BOARD ACTION REPORT – APPEALABLE ITEM

Project Name: Atlantic Crossing (Building I & III) (2021-200)

Request: Class I Site Plan Modification

Meeting Date: August 25, 2021

SITE PLAN

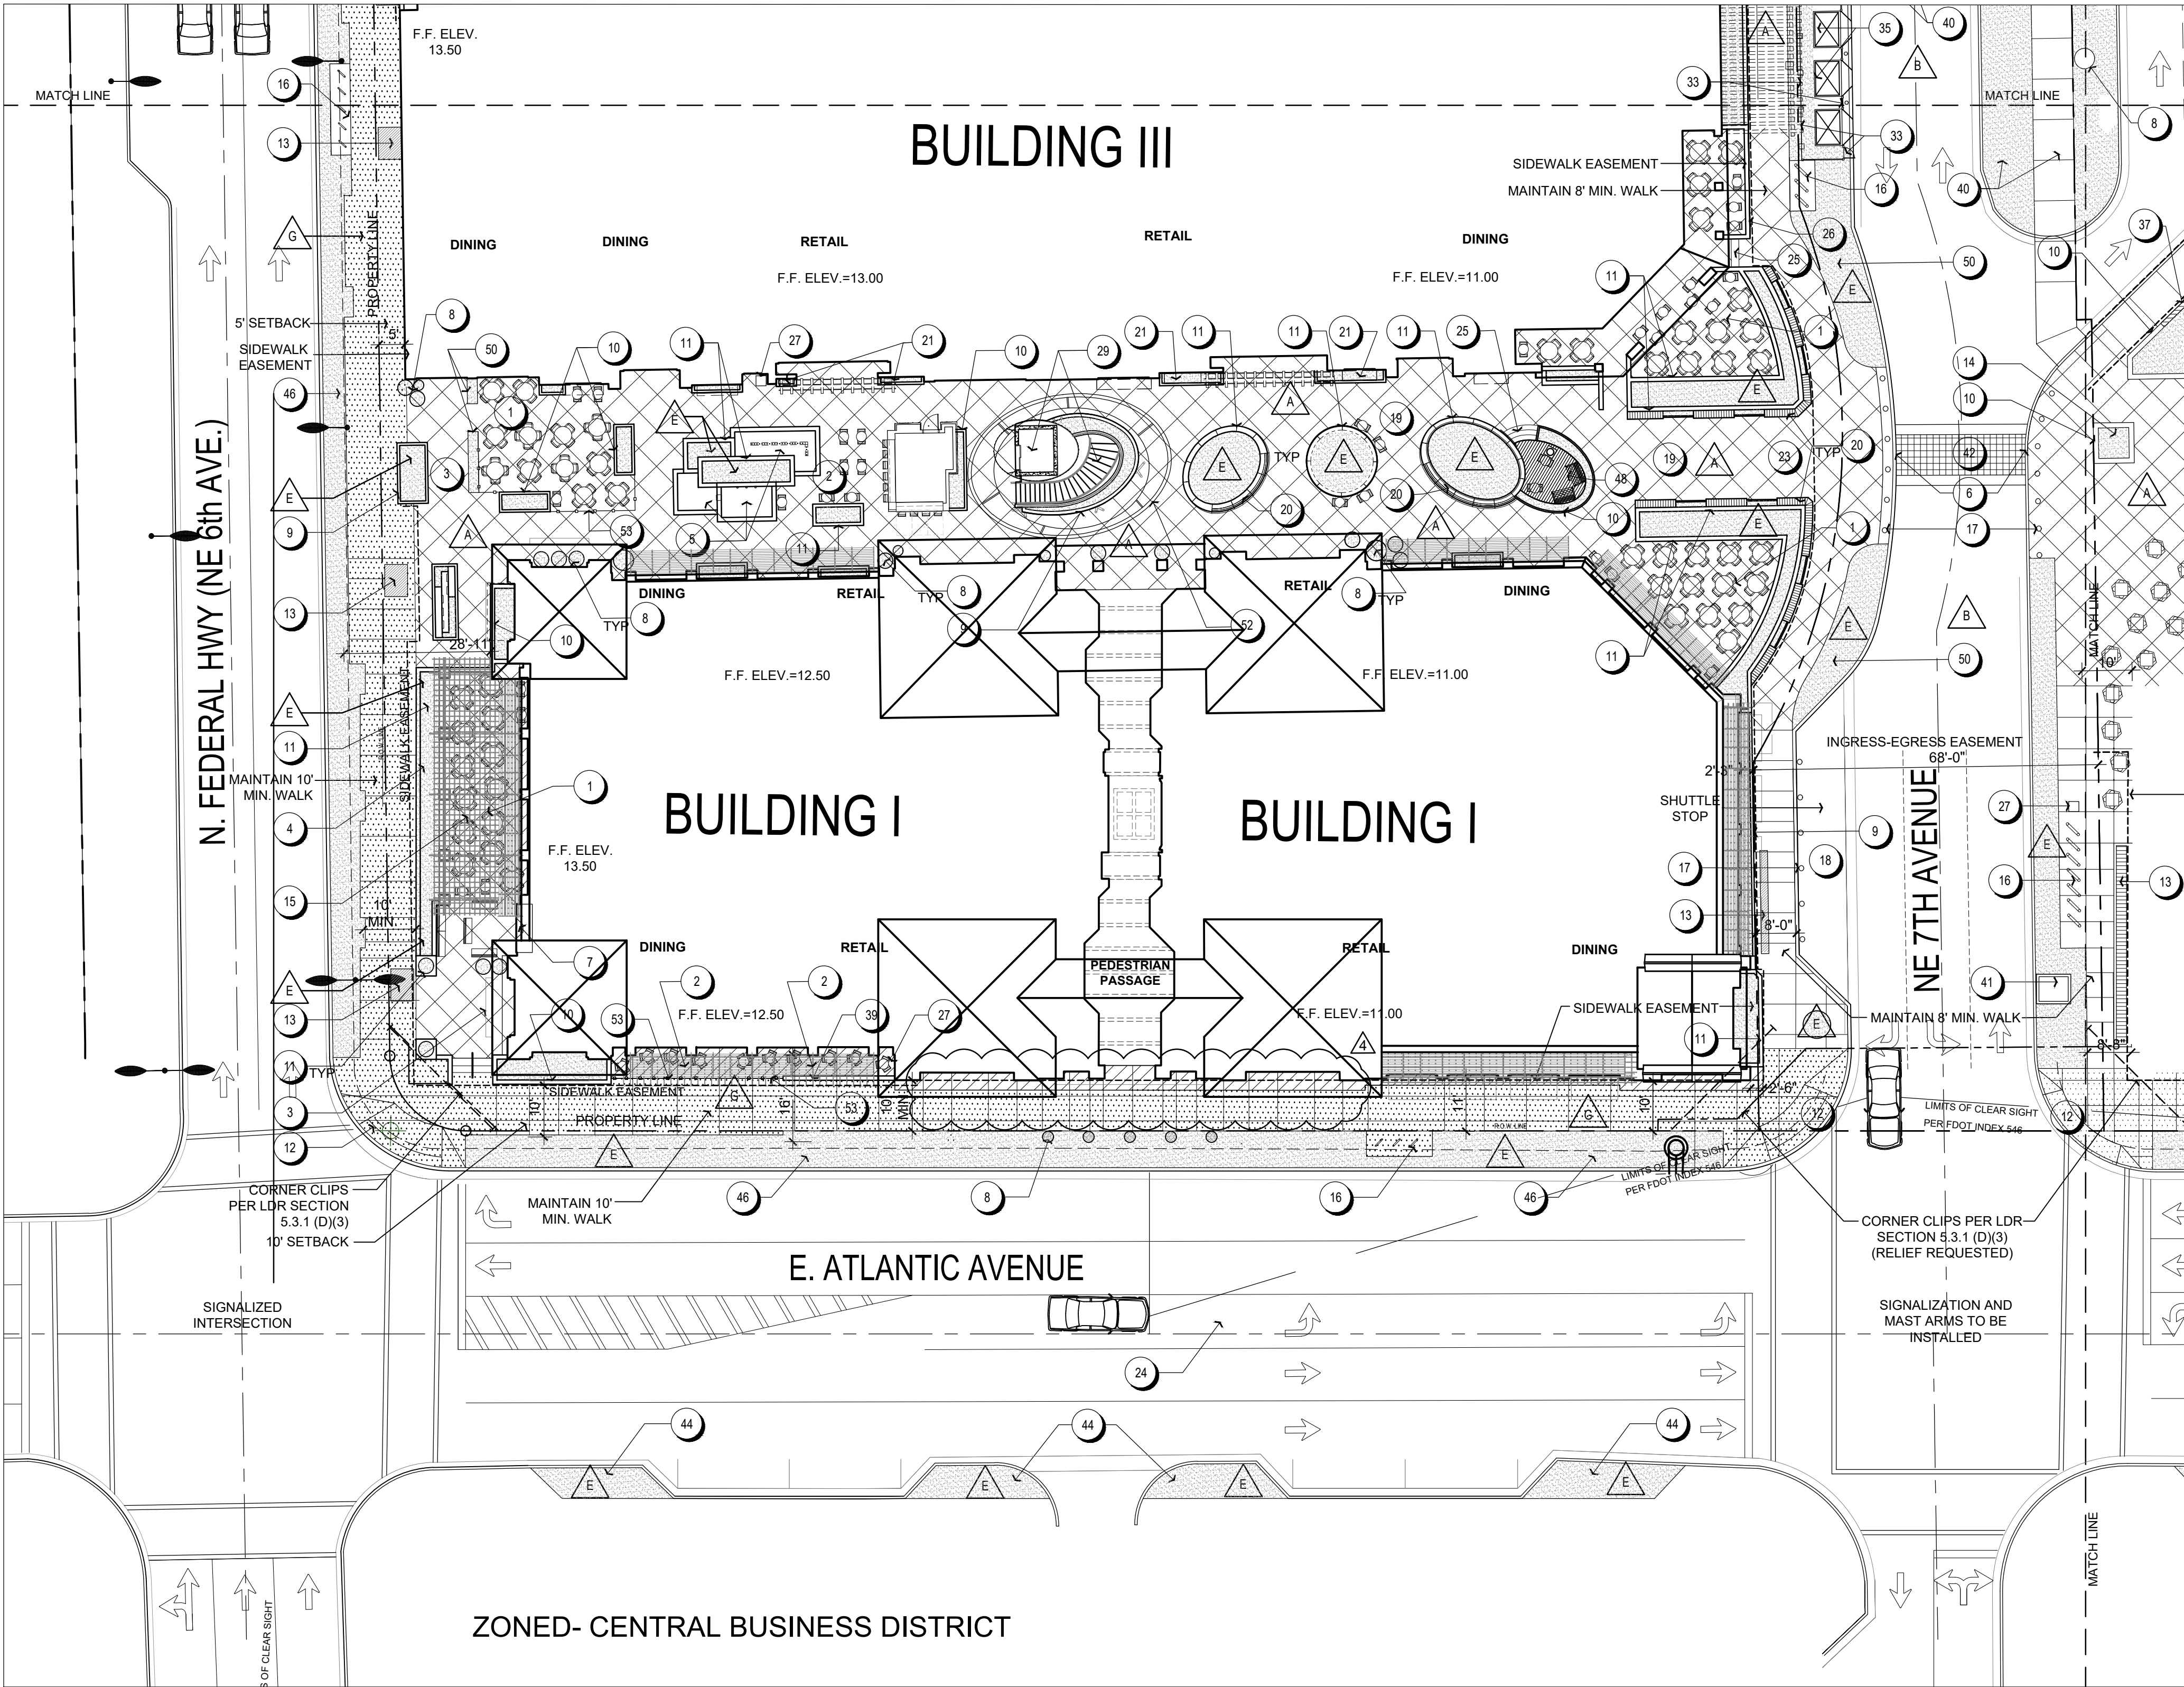
SPRAB NOTE 04/19/2021:

- 1. REMOVAL OF THE BUILDING TRELLIS AS REQUIRED BY FDOT

B BLDG I WALL SECTION
SCALE: 1/4" = 1'-0"

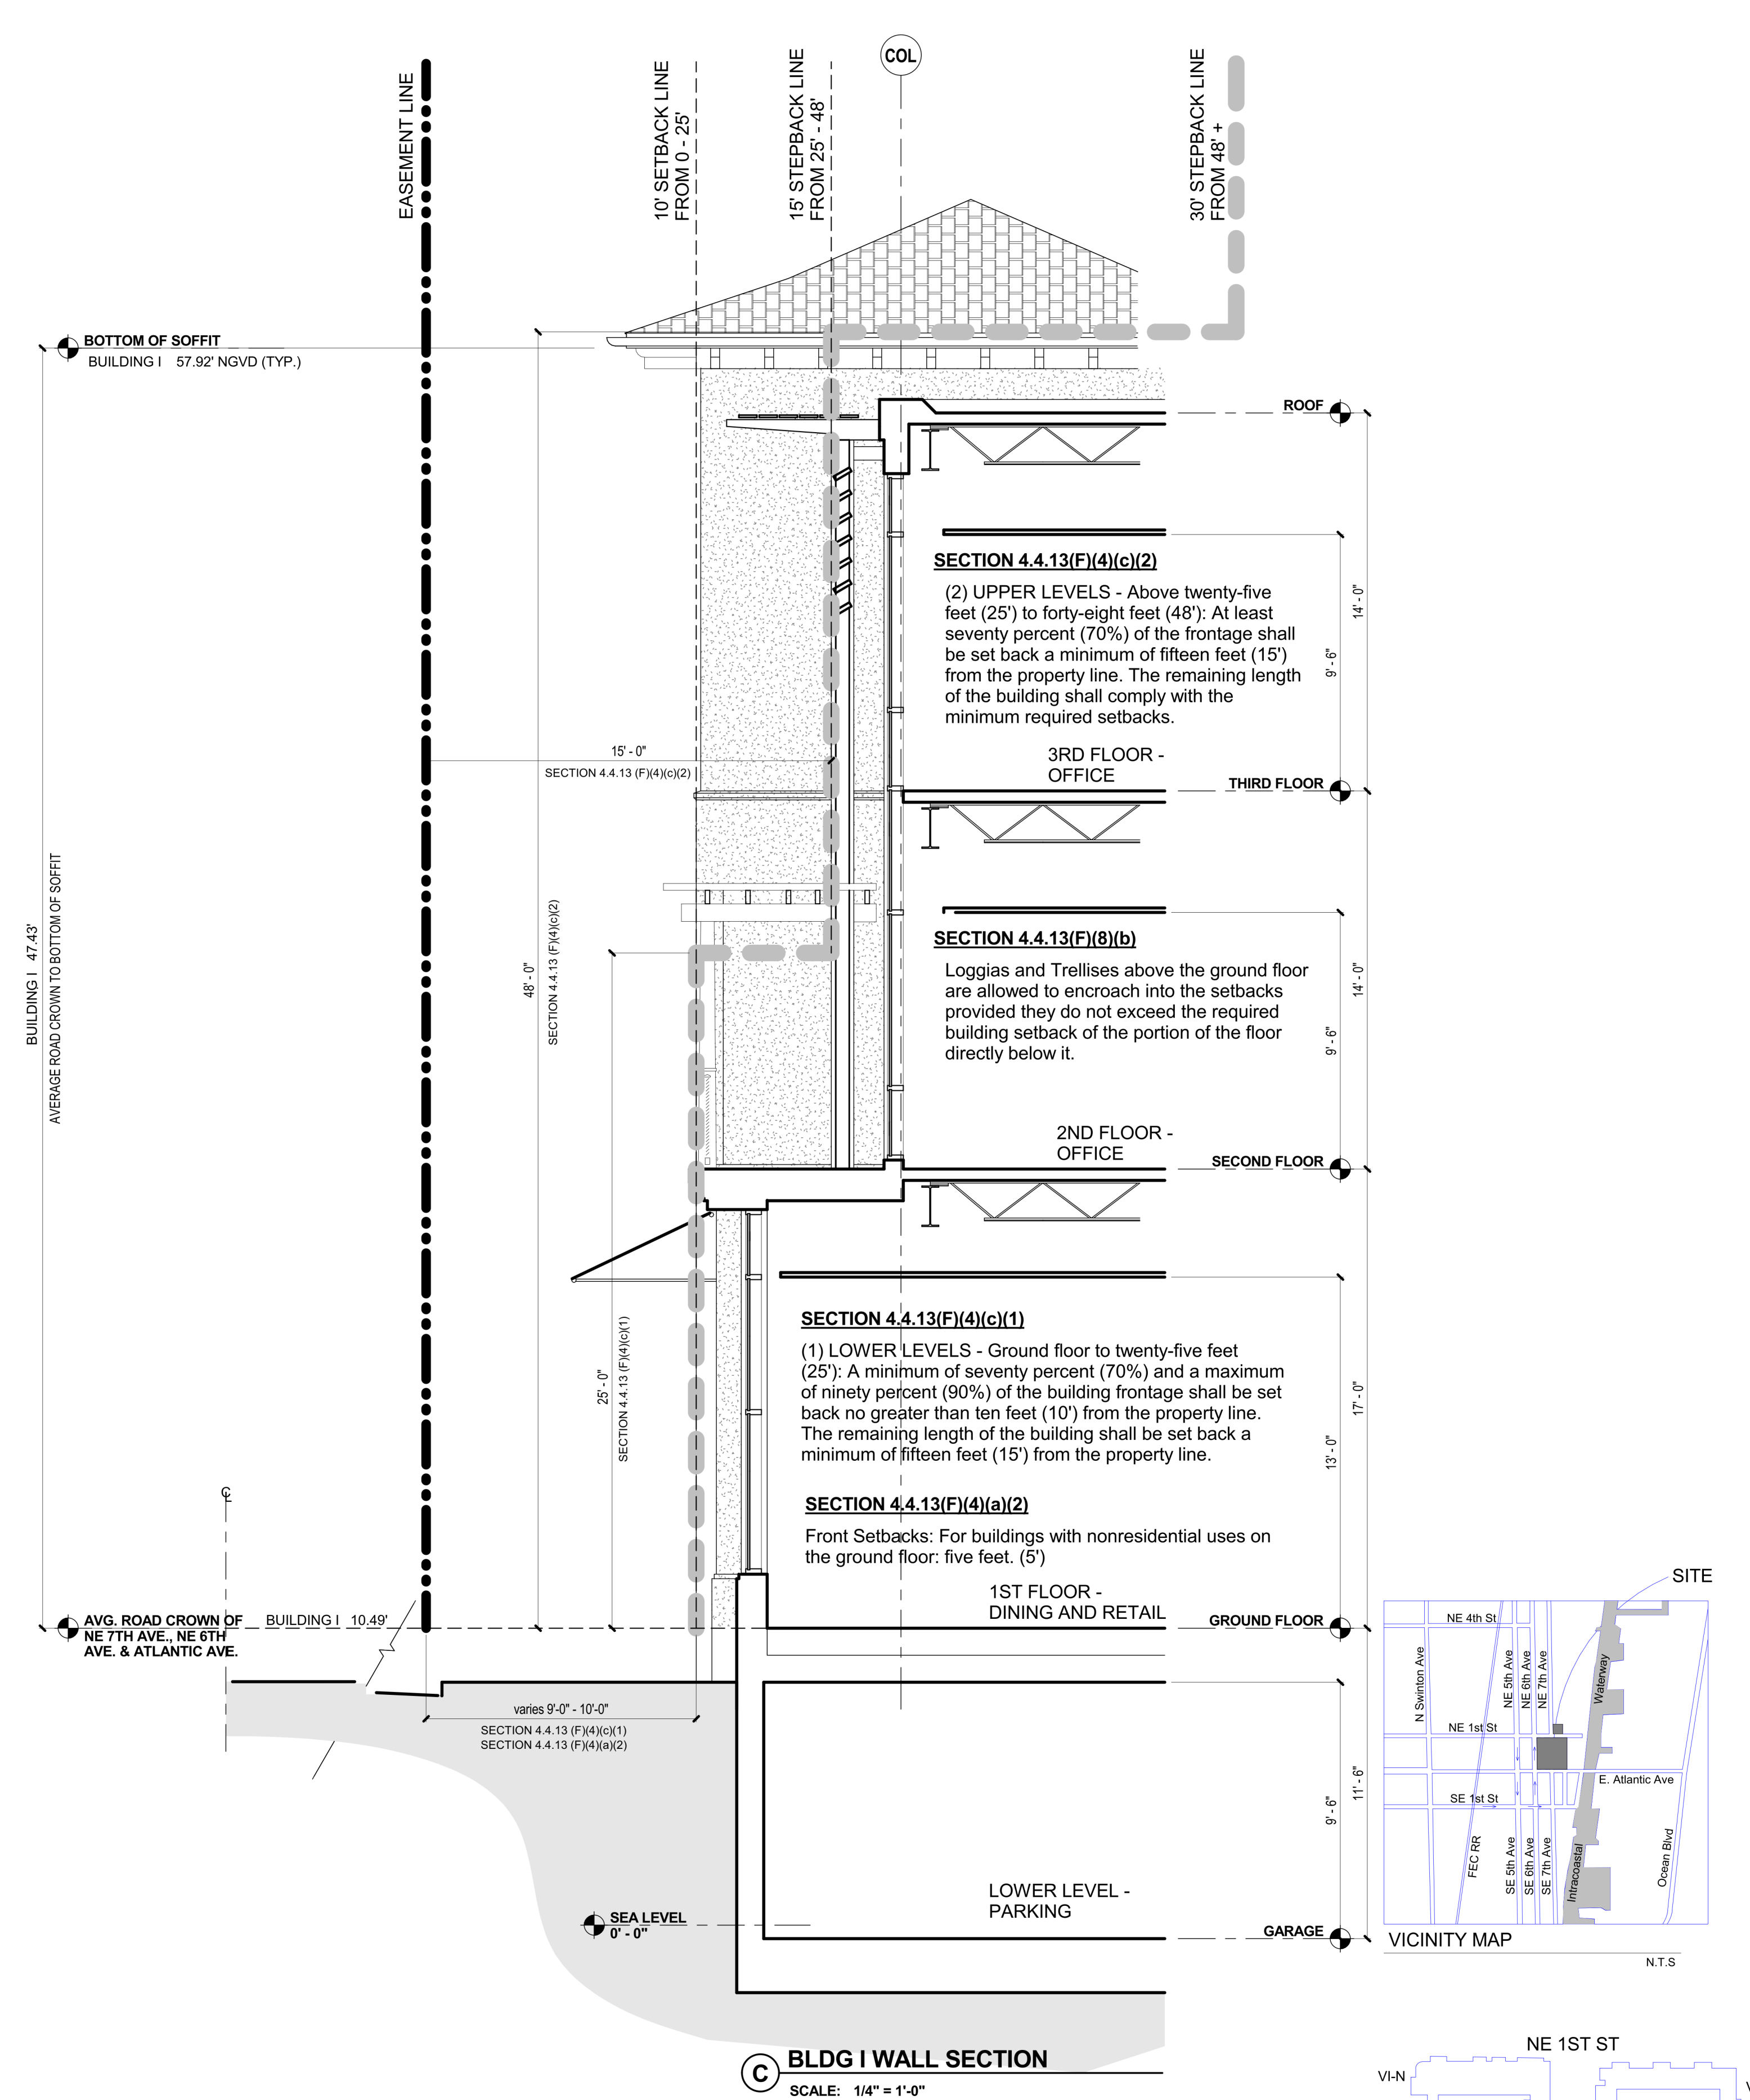
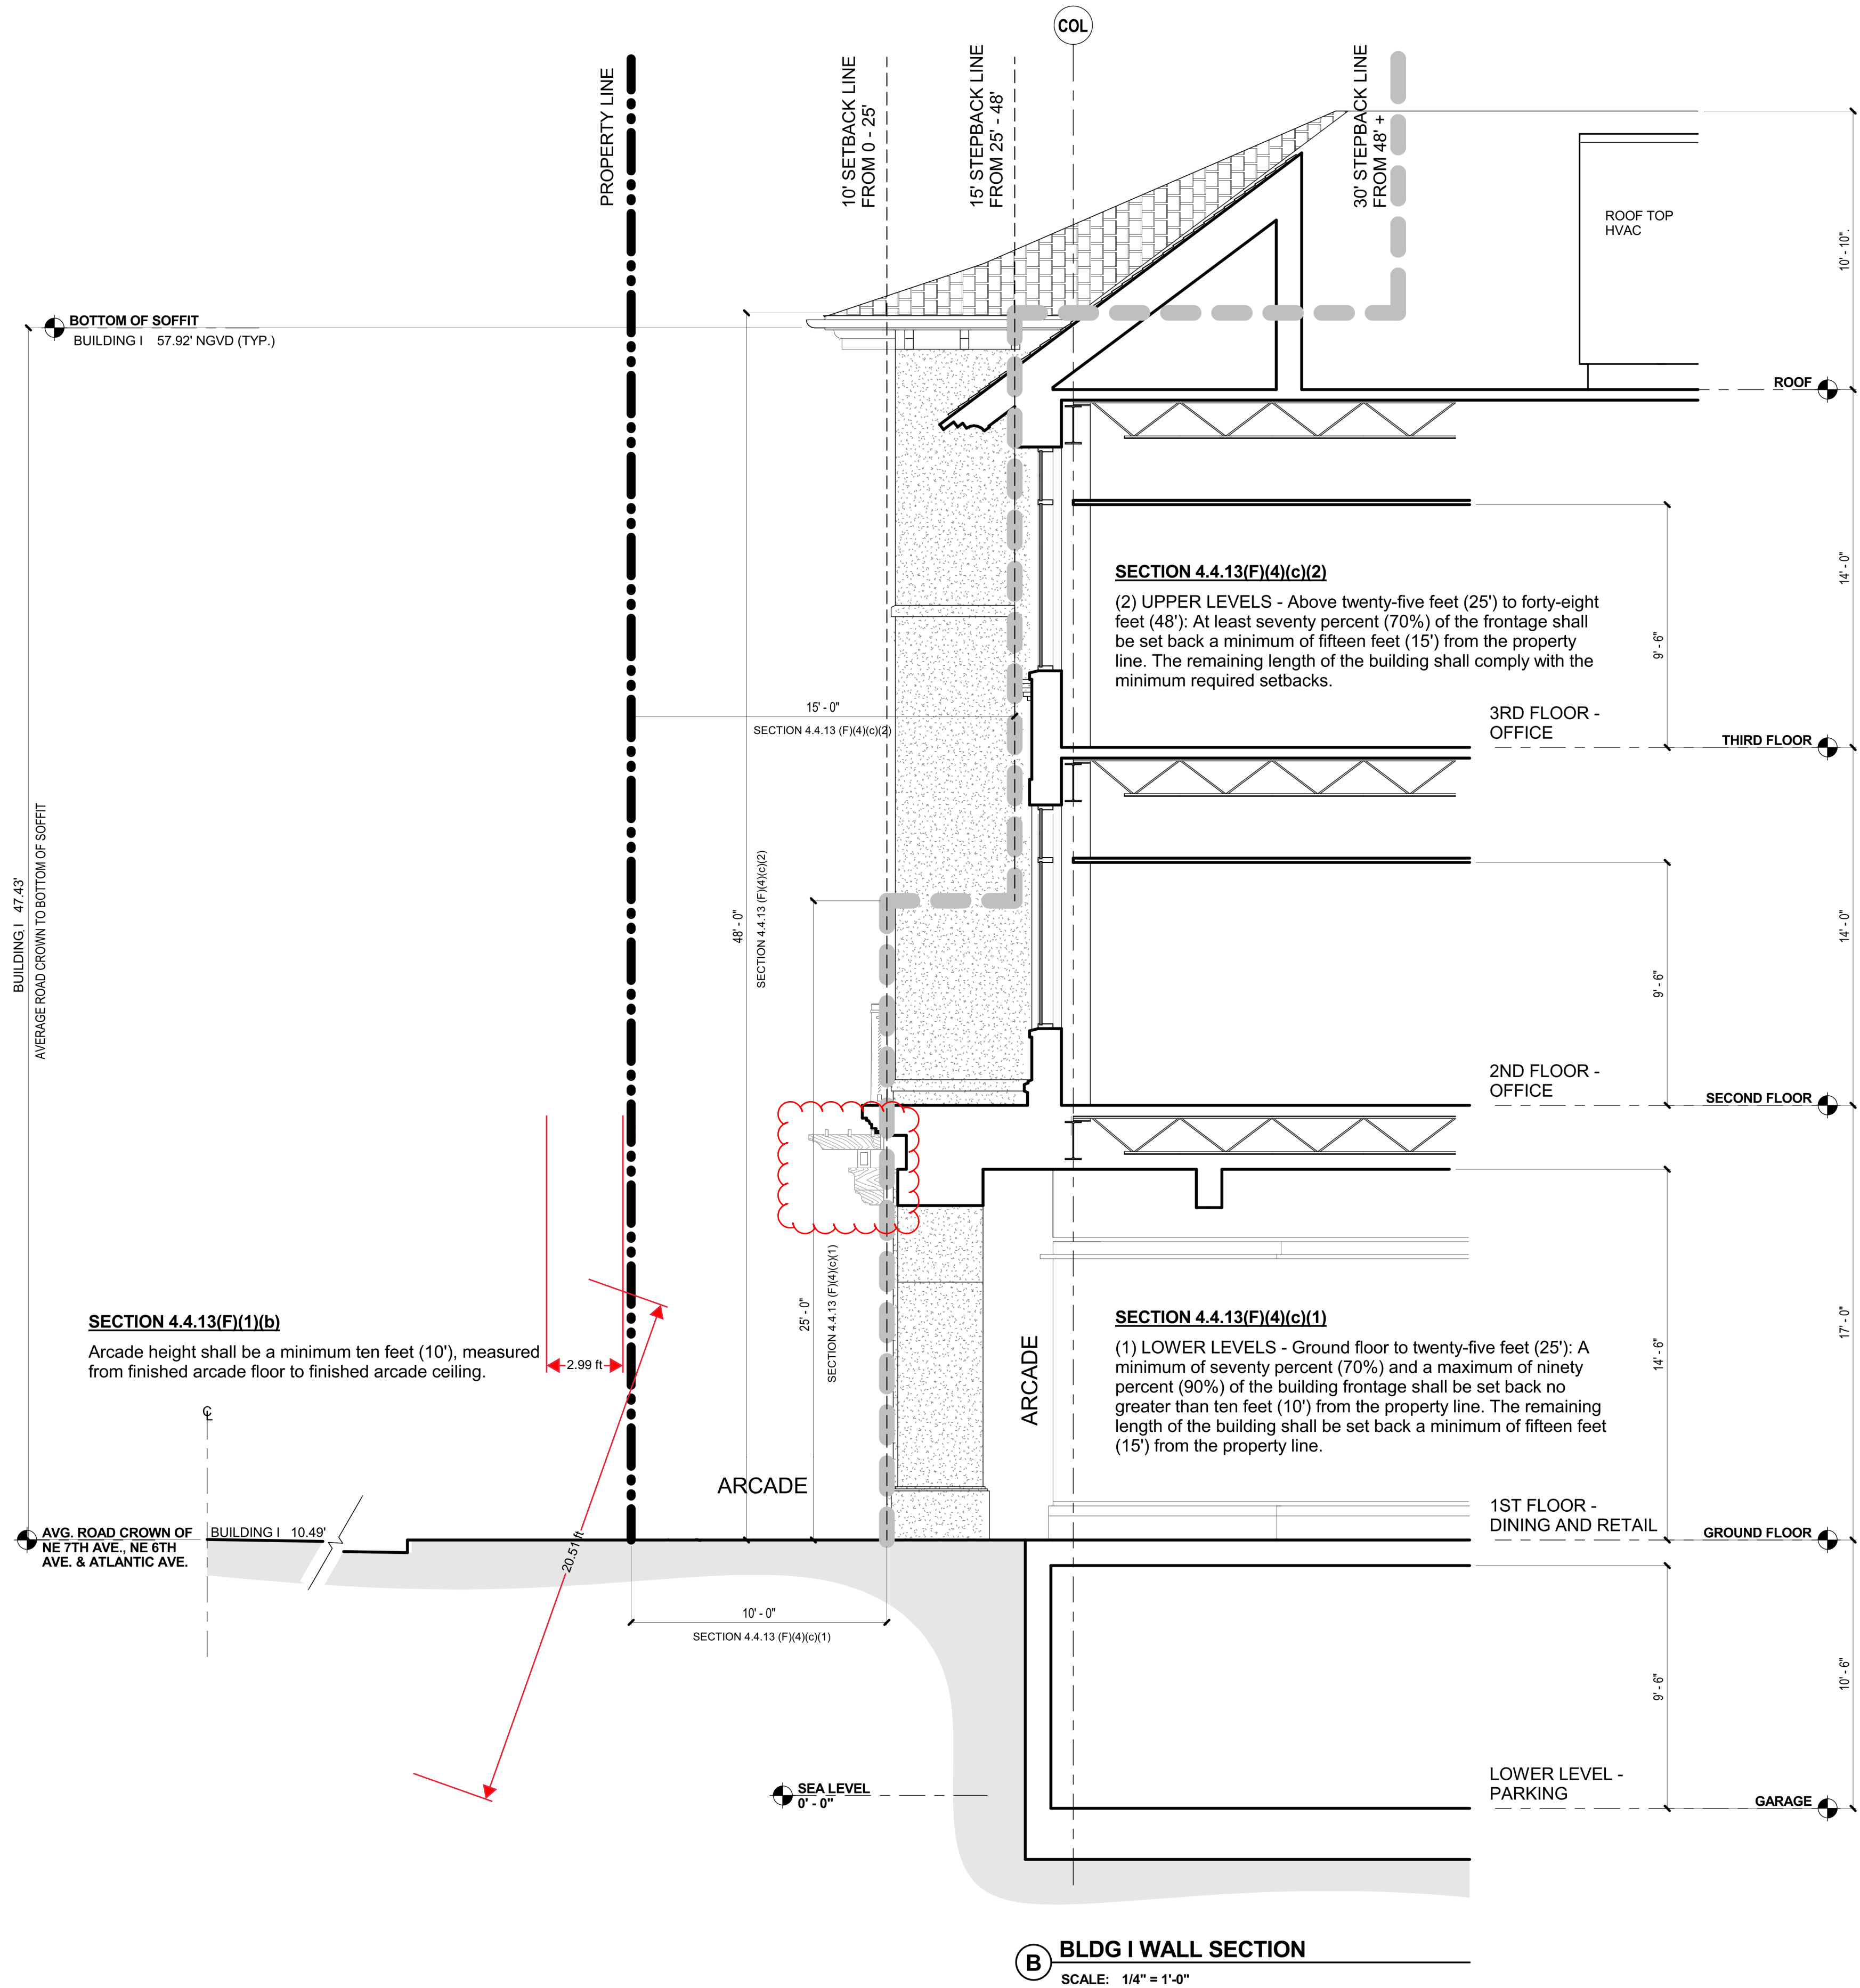
The modification to Building I includes the replacement of a trellis with support columns spanning the width of the entire south elevation, facing East Atlantic Avenue. The replacement is required by the Florida Department of Transportation (FDOT) review, who owns this portion of East Atlantic Avenue. The solution proposed by the applicant is to add individual trellis awnings at a smaller depth of three feet so that support columns are no longer required. The new awnings will be located above two storefronts and the pedestrian passageway leading to the internal courtyard and providing access to the balance of the development. The modifications to Building III includes increasing the green wall area located on the second and third stories of the south and west elevations by eliminating transom windows located below the larger picture windows. The entrance to a commercial space on the easternmost portion of the south elevation is being review from a covered storefront entry to an arched entry finished to match the balance of the building.
